ADDENDUM NO. 2

**TASMG READINESS CENTER
AVCRAD Facility
Springfield, Missouri
PROJECT NO.: T1809-01**

Bid Opening Date: 1:30 PM, Thursday, May 21, 2020 (Not Changed)

May 7, 2020

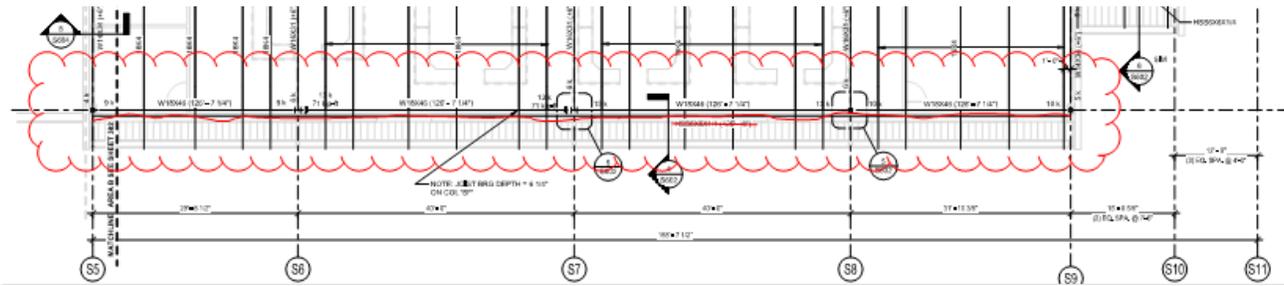
7. Sheet S301 – AREA A-ROOF FRAMING PLAN

- a. DELETE horizontal HSS6x6x1/4 at elevation 125'-8" shown on column line SF between column lines S5 and S9. Refer to architectural drawings for column lines and image below for additional information.

1 PARTIAL FLOOR PLAN - AREA B
 1/4" = 1'-0"

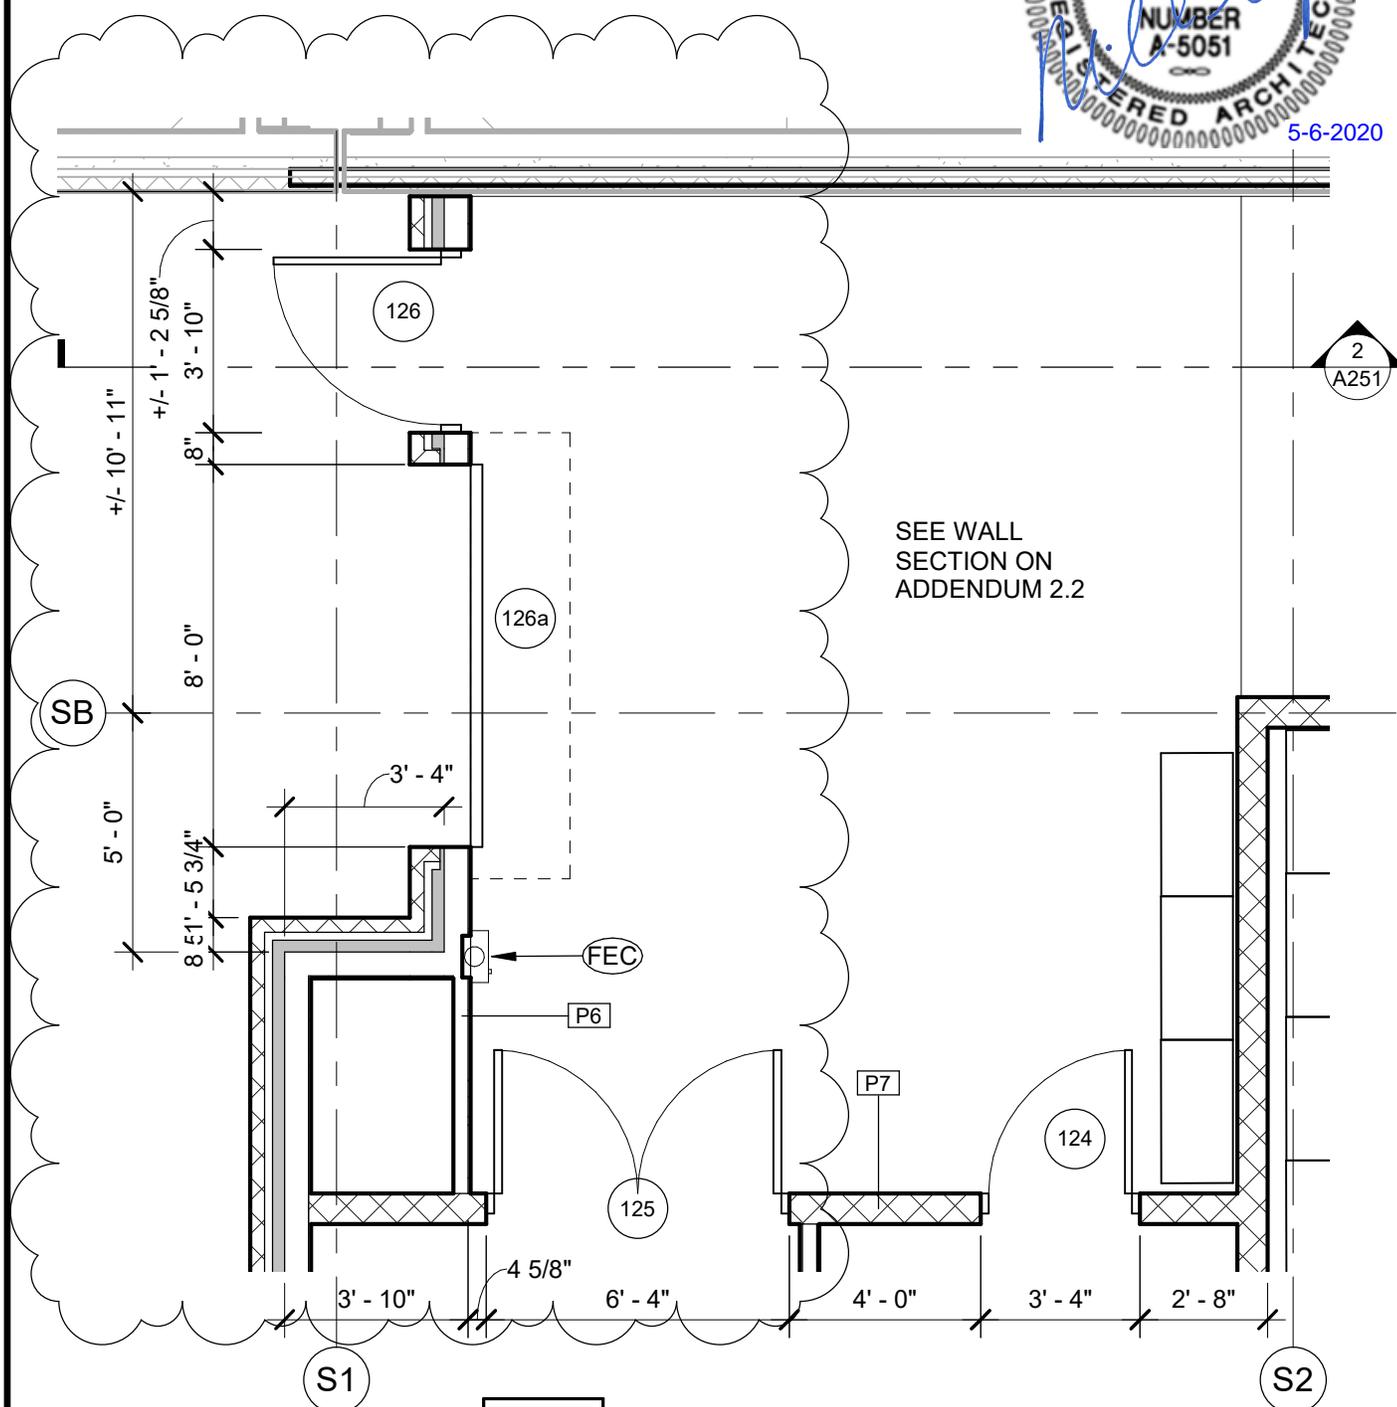
4. Sheet A110 – FIRST FLOOR PLAN – AREA B

- a. See attached 1. PARTIAL FLOOR PLAN – AREA B for loading dock revisions and exterior wall relocation with new structural overhang.

3 WALL SECTION
 1/2" = 1'-0"

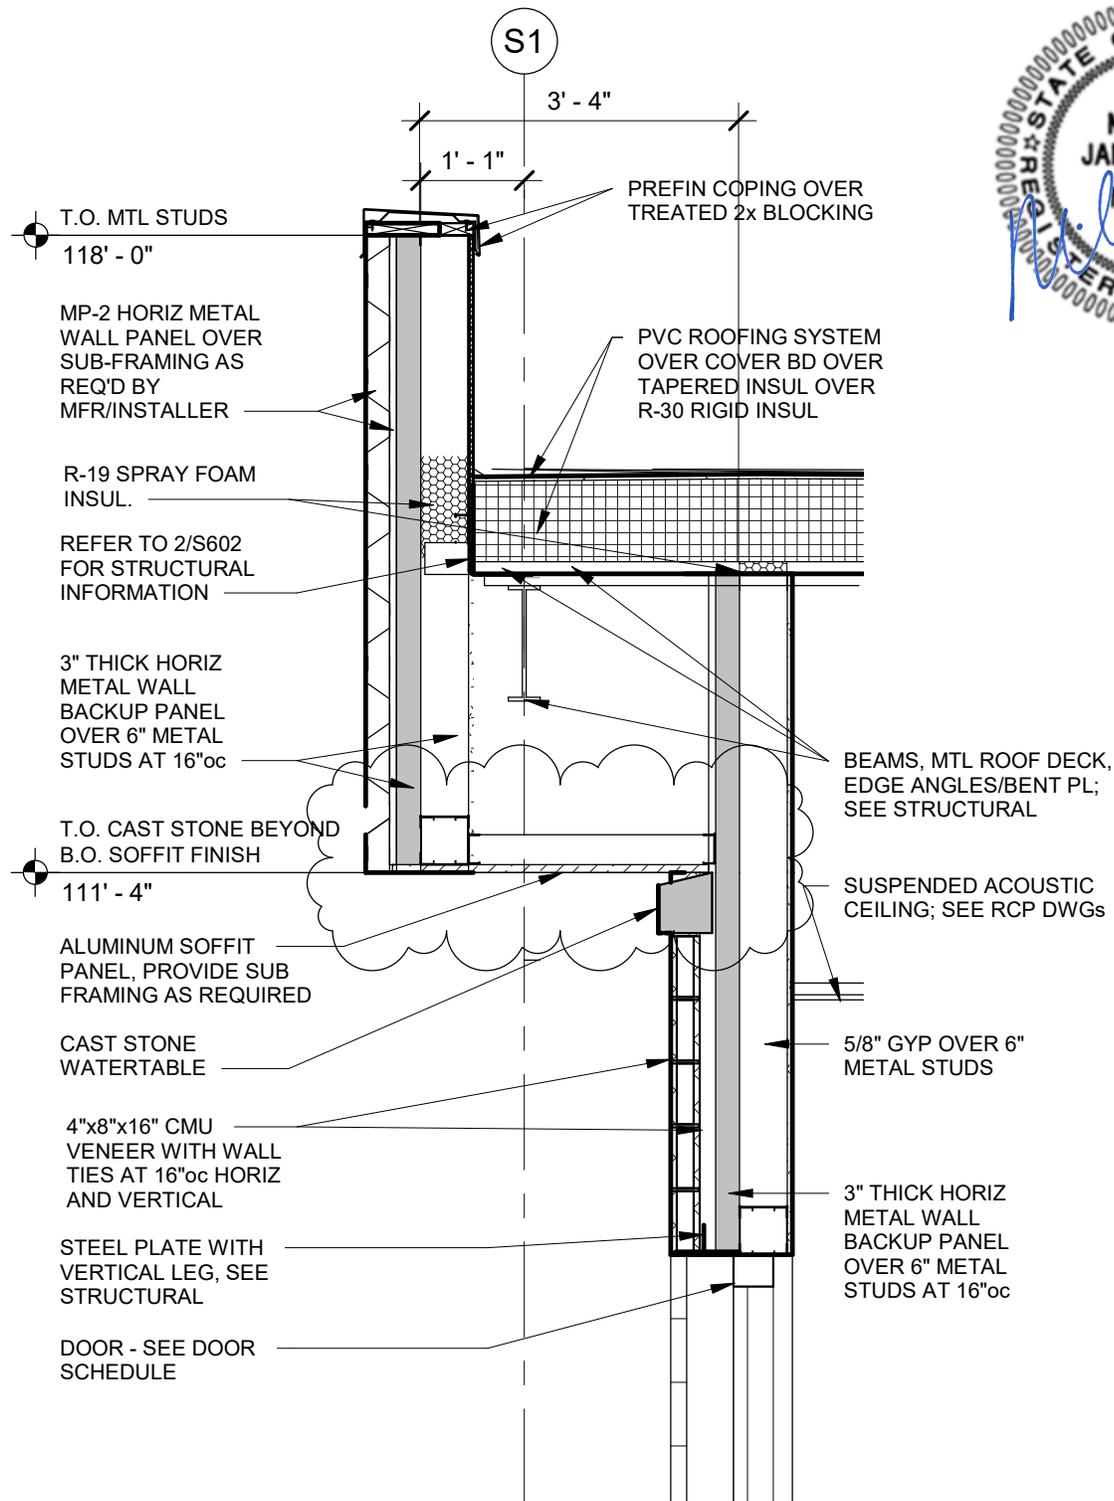
5. Sheet A302 – WALL SECTIONS

- a. See attached 3. WALL SECTION modifying profile of exterior wall at column line S1.

1 AREA B FOUNDATION PLAN
SCALE = 1/8" = 1'-0"

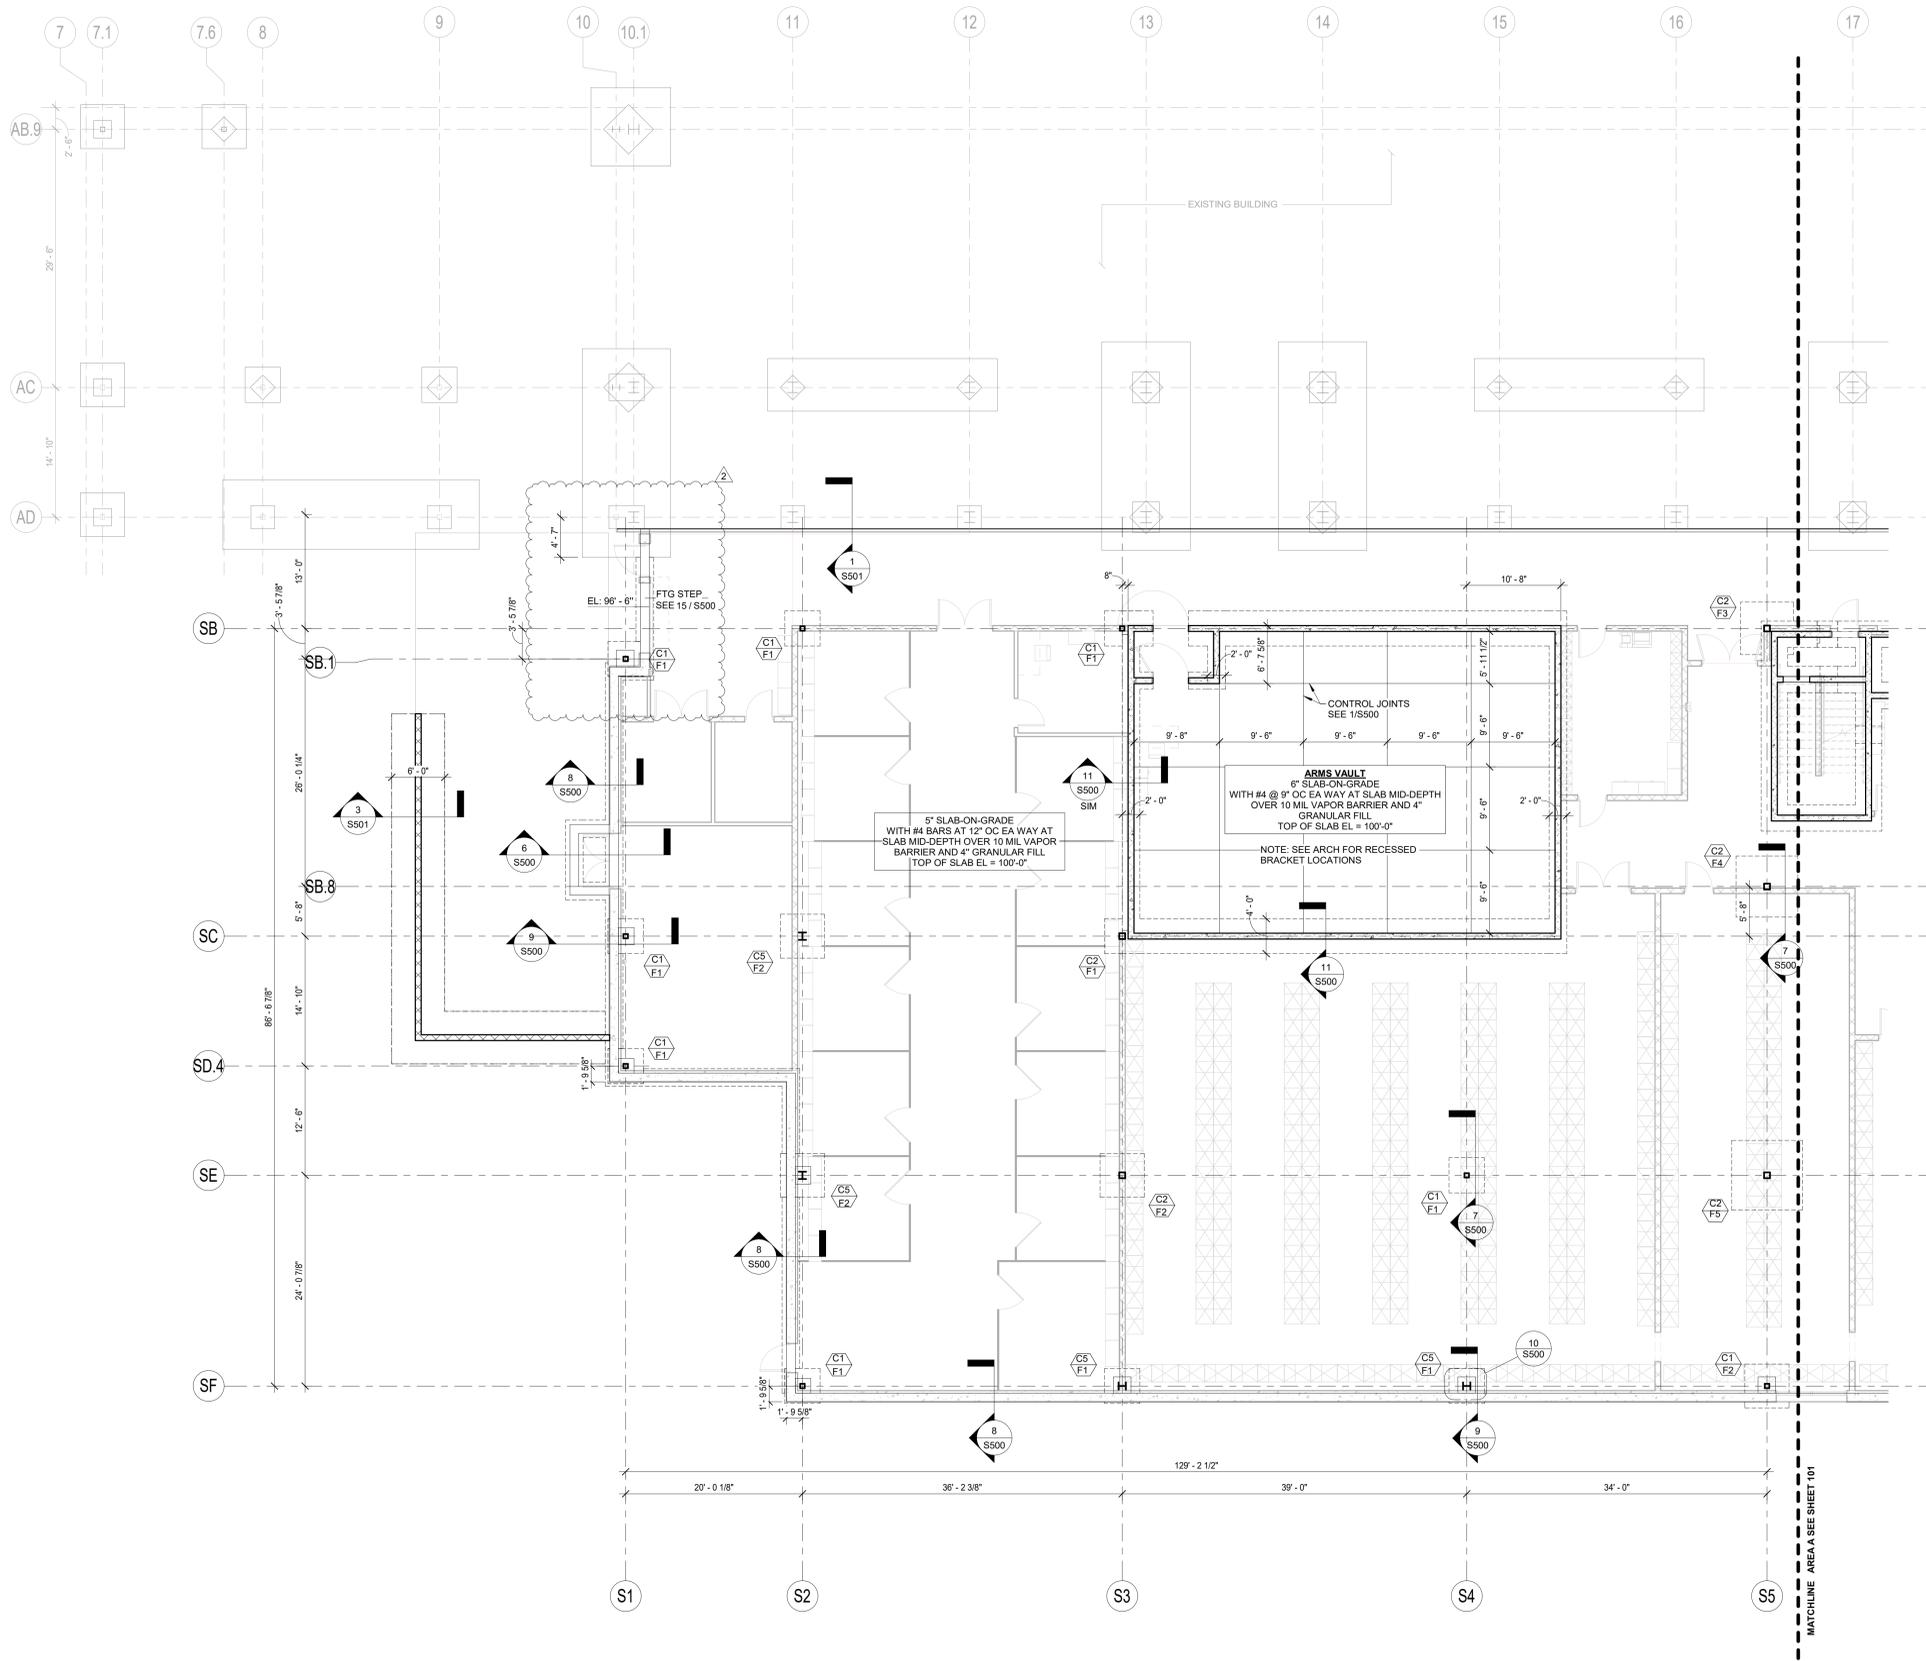
6. Sheet S102 – AREA B FOUNDATION PLAN

- a. See attached revised Sheet S102 – AREA B FOUNDATION PLAN for loading dock revisions and exterior wall relocation with new structural overhang.

FIRST FLOOR MECHANICAL
PIPING PLAN - AREA B

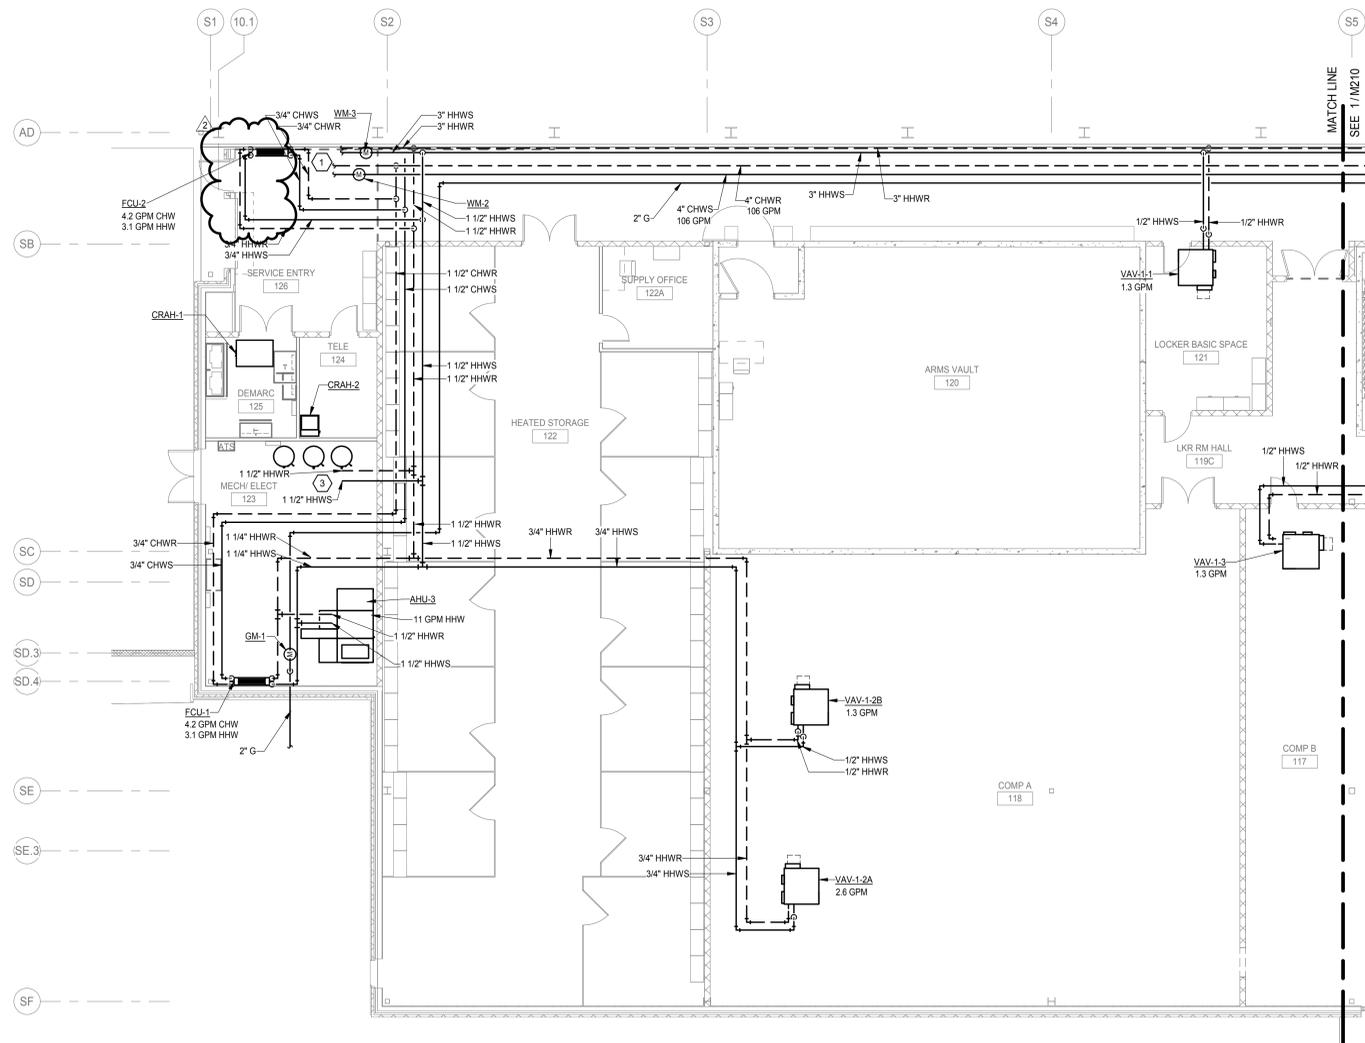
8. Sheet M211 – FIRST FLOOR MECHANICAL PIPING PLAN – AREA B

- a. See attached revised Sheet M211 – FIRST FLOOR MECHANICAL PIPING PLAN-AREA B for changes to hydronic piping locations related to loading dock wall adjustments.

FIRST FLOOR WASTE & VENT
PLUMBING PLAN - AREA B

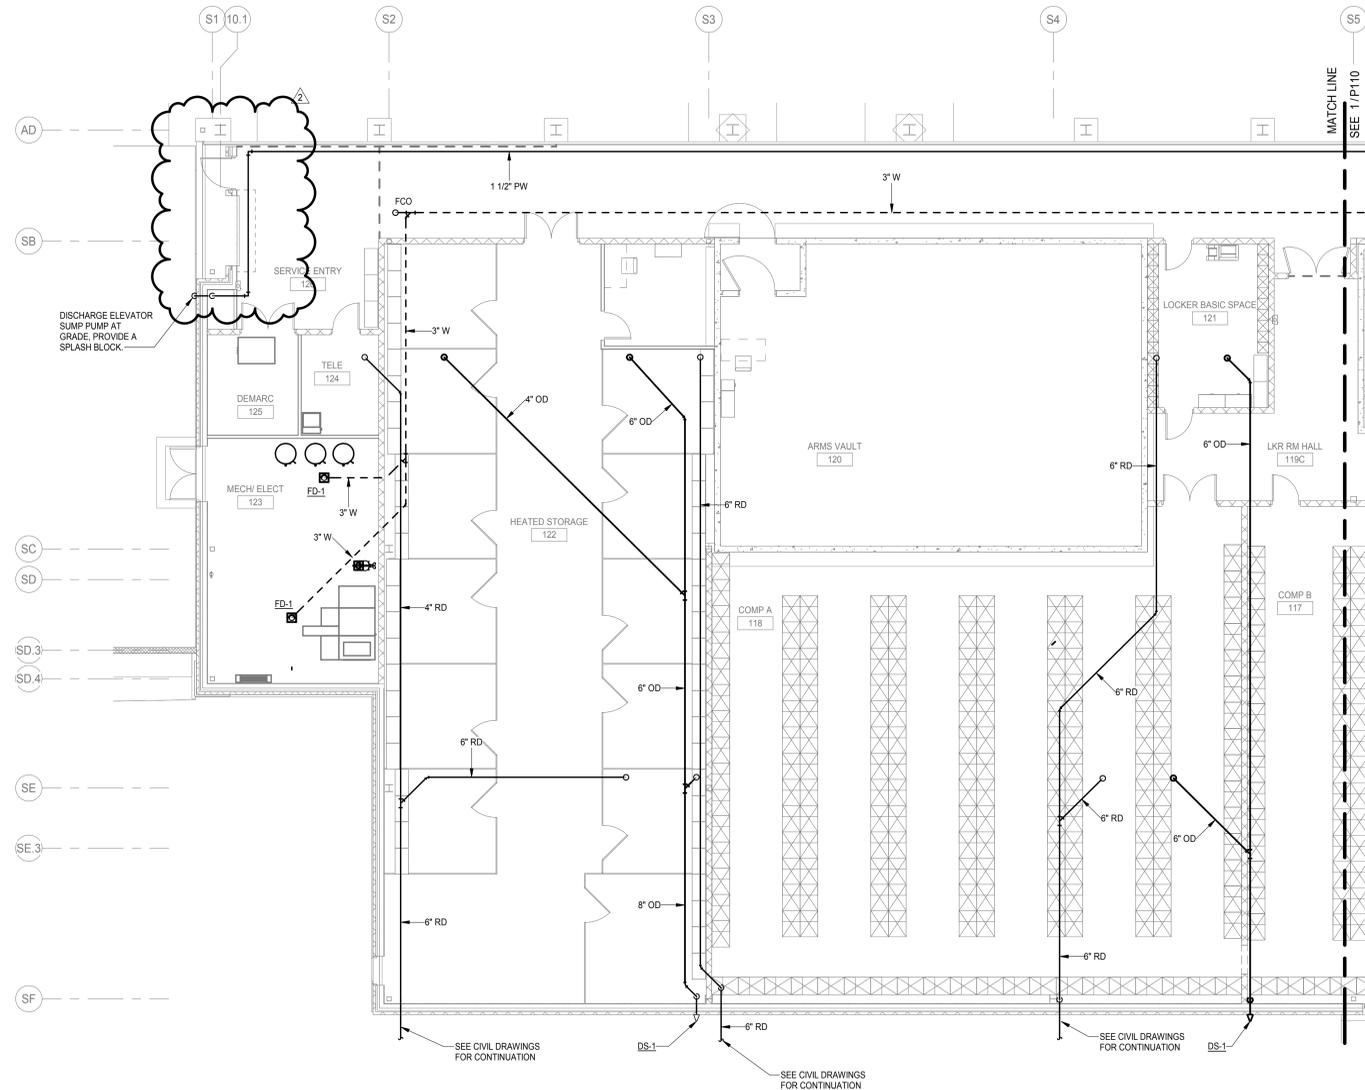
9. Sheet P111 – FIRST FLOOR WASTE AND VENT PLUMBING PLAN – AREA B

- a. See attached revised Sheet P111 – FIRST FLOOR WASTE AND VENT PLUMBING PLAN-AREA B for changes to sump pump discharge and adjacent building overflow drain piping.
